Re: 5752-00-02 Curb Ramp Design Summary

Project ID: 5752-00-02/72
USH 14 – La Valle
Lee Lake Bridge to STH 33
STH 58
Richland and Sauk Counties

Attachment D: Technical Infeasibility Documentation

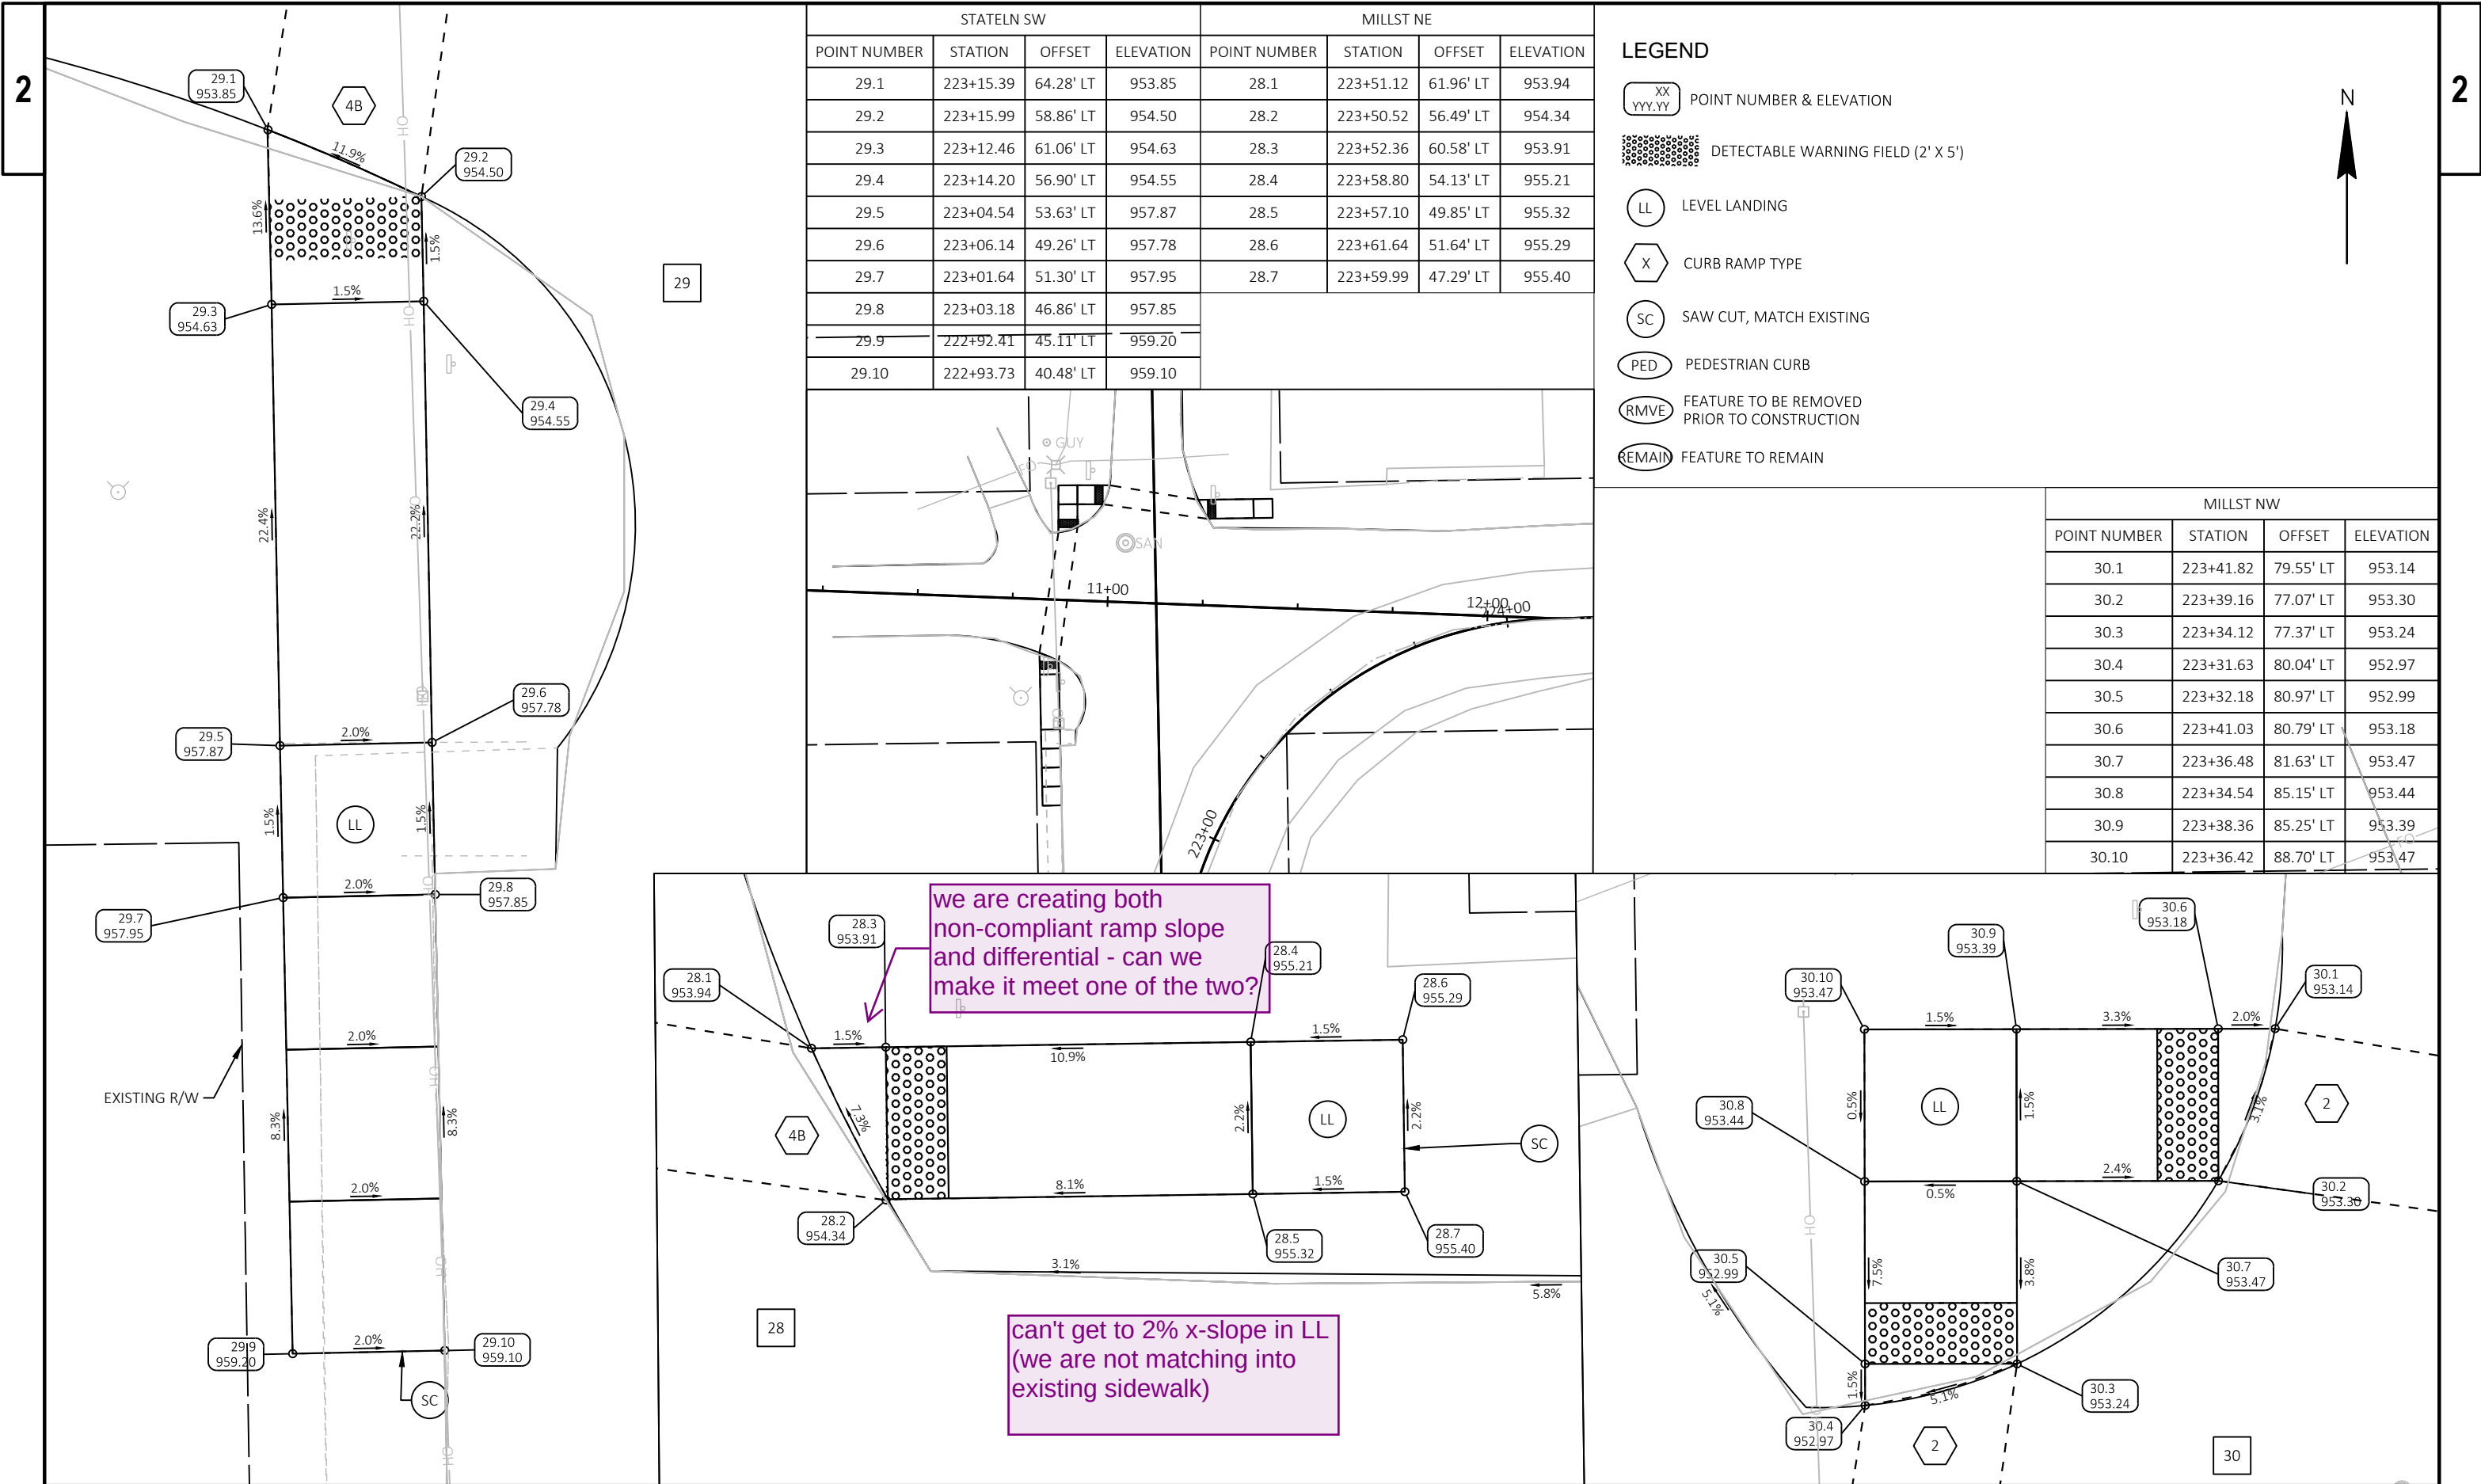
we are creating both non-compliant ramp slope and differential - can we make it meet one of the two?

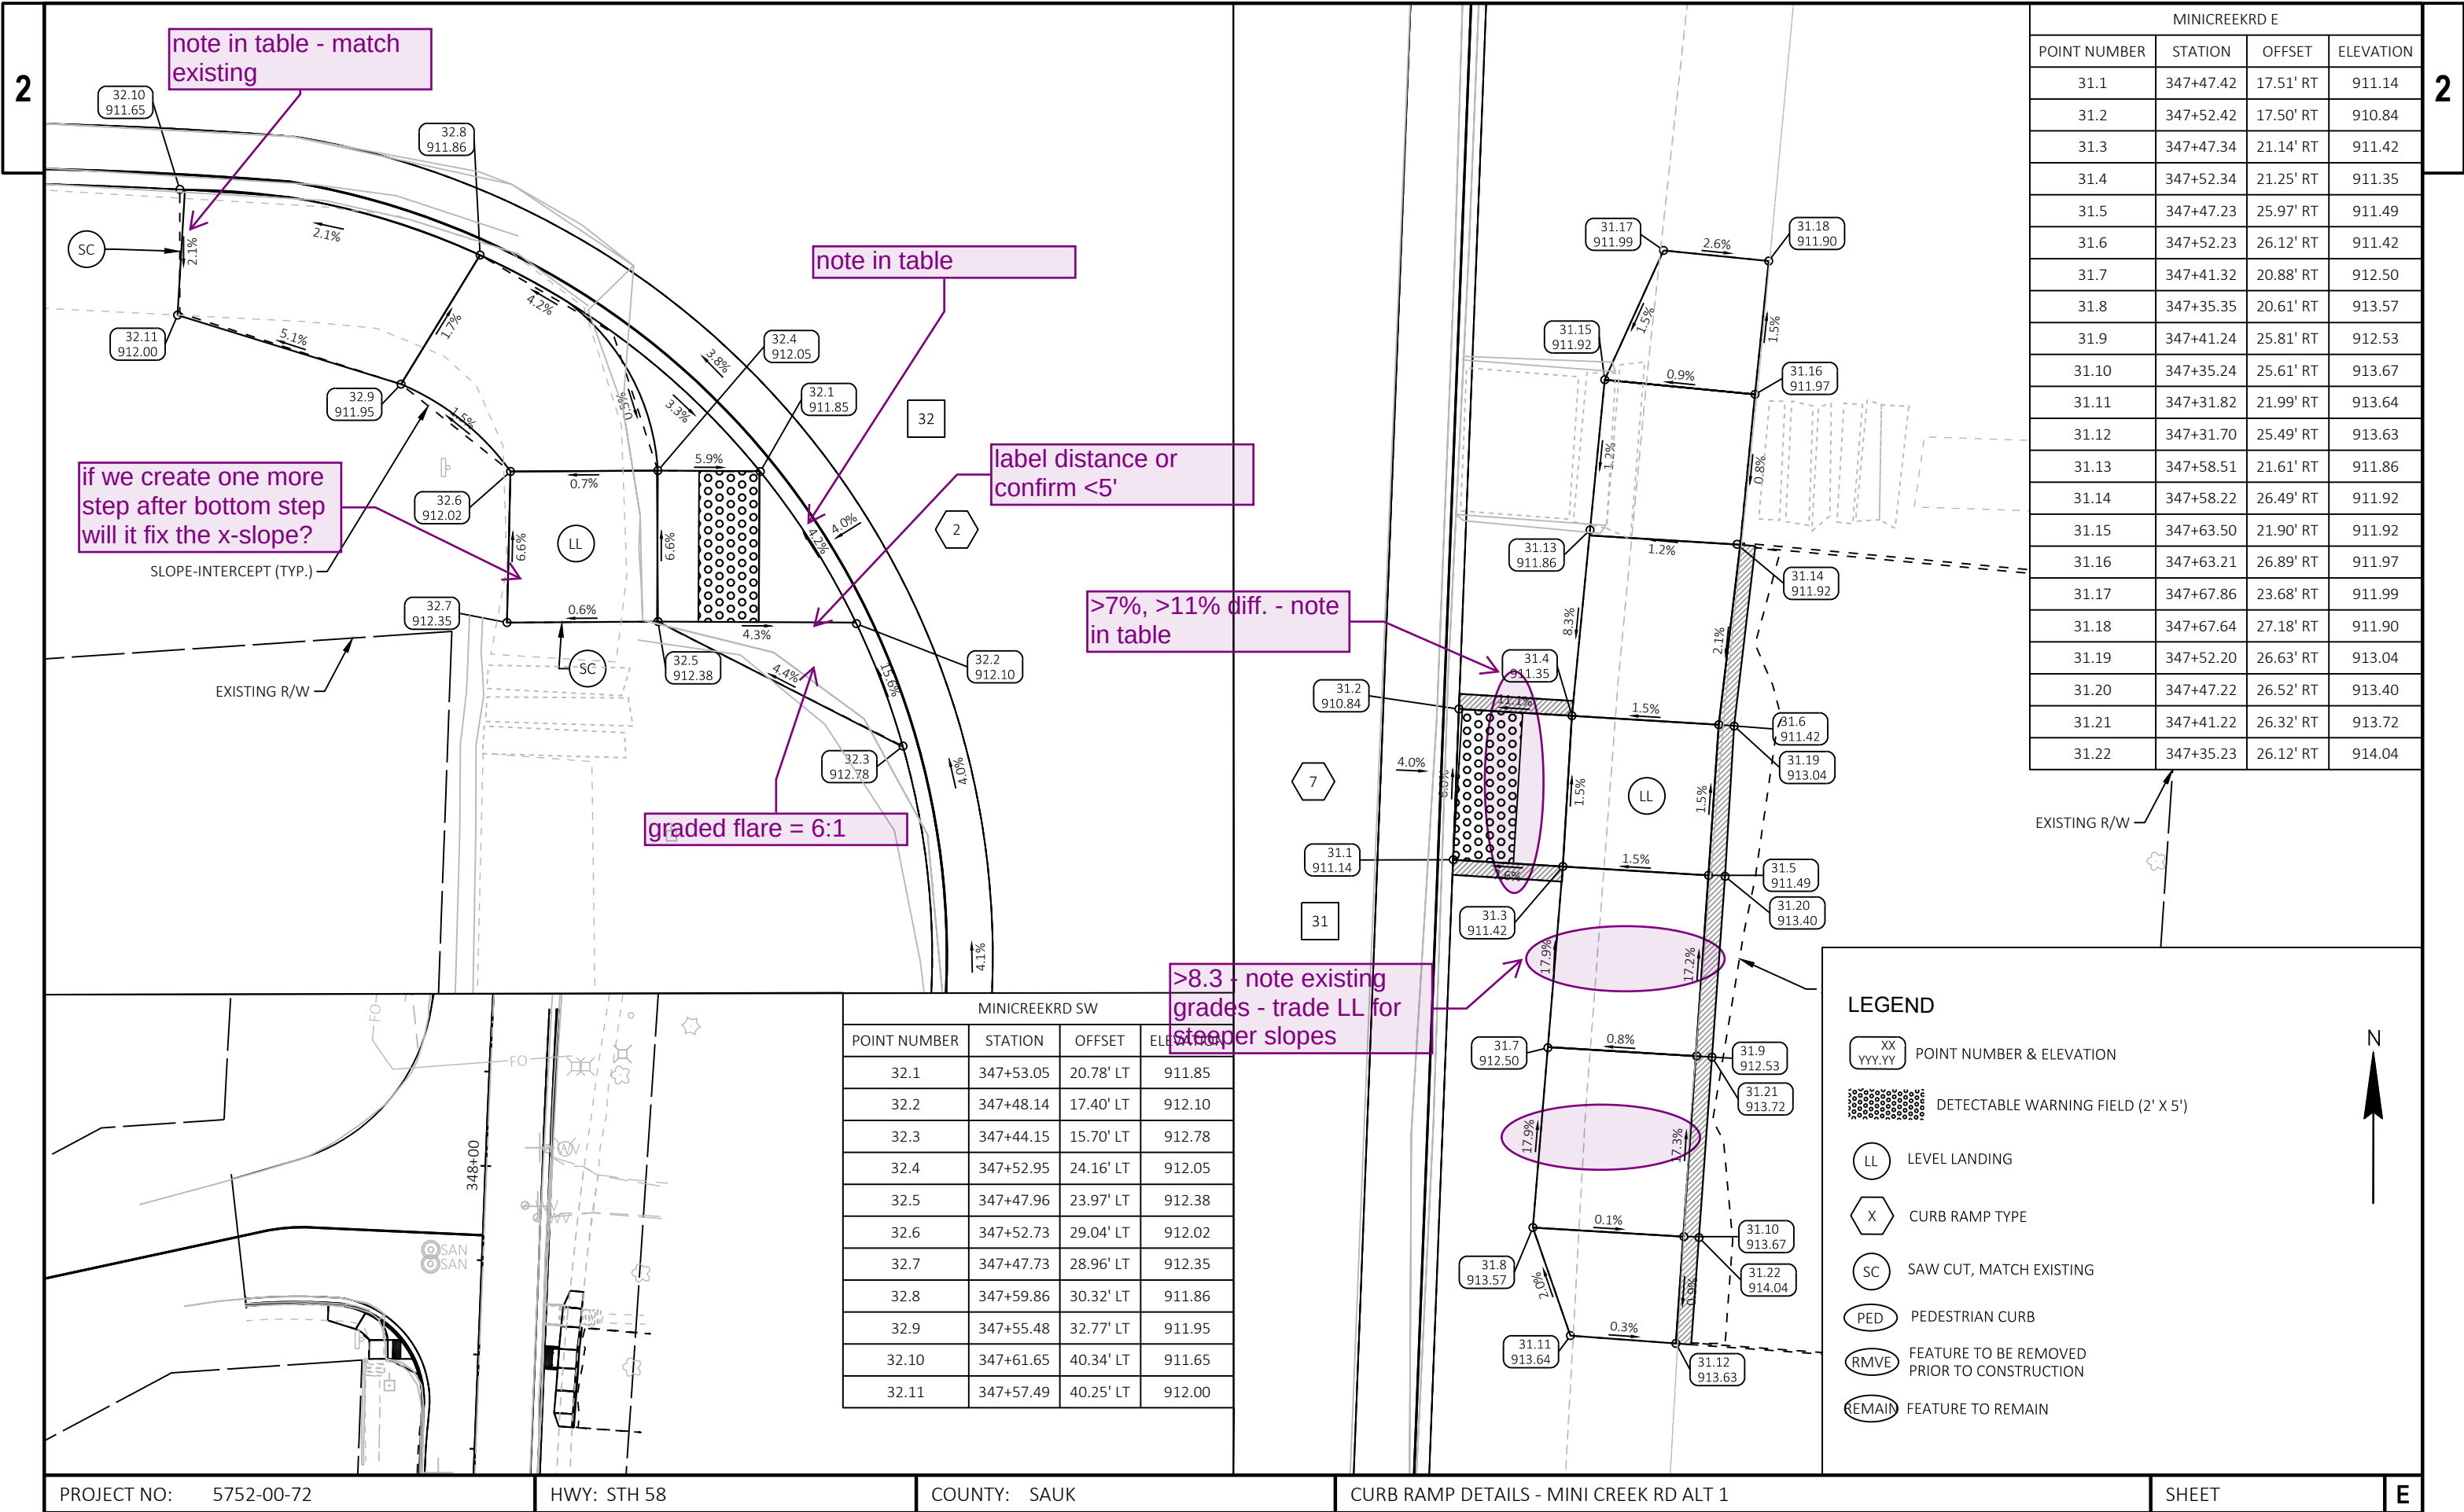
can't get to 2% x-slope in LL (we are not matching into existing sidewalk)
